PHAP26-00006

ITEM #2

Certificate of Appropriateness for enclosure of the carport to create a garage

PROPOSED ELEVATIONS

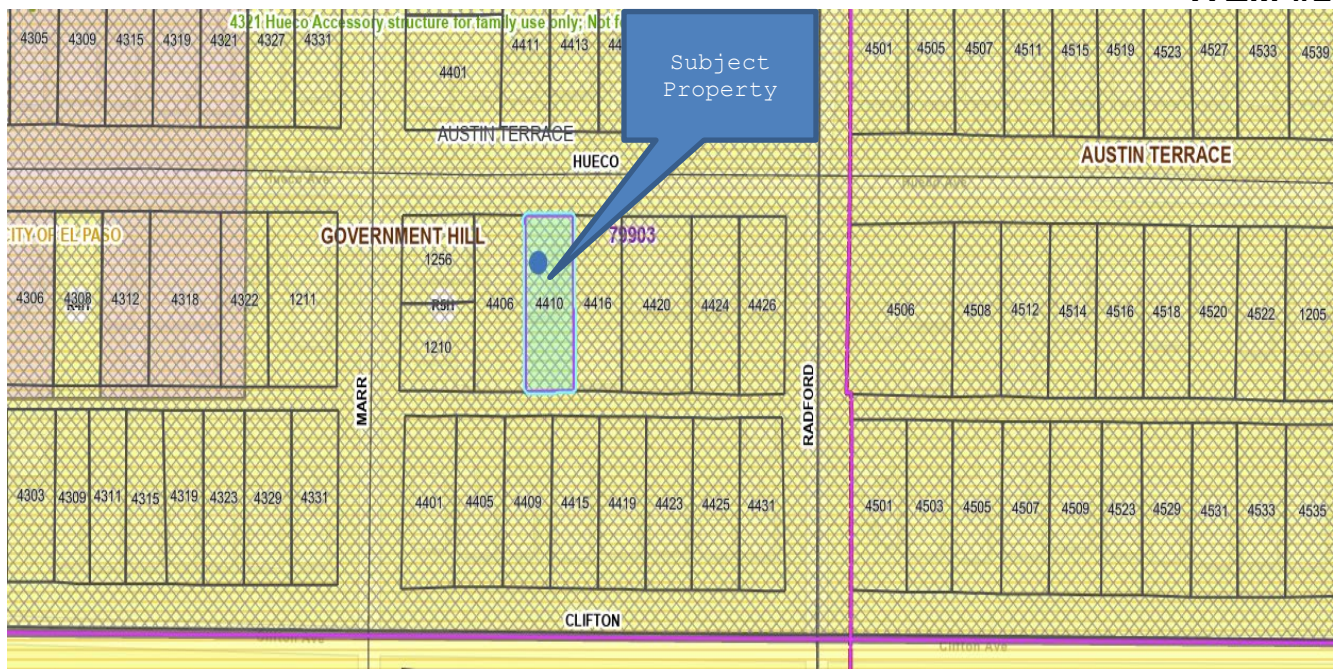
The Historic Preservation Office recommends APPROVAL WITH A MODIFICATION of the proposed scope of work based on the following recommendations:

The modification is that the no permits are issued until the window violation is corrected.
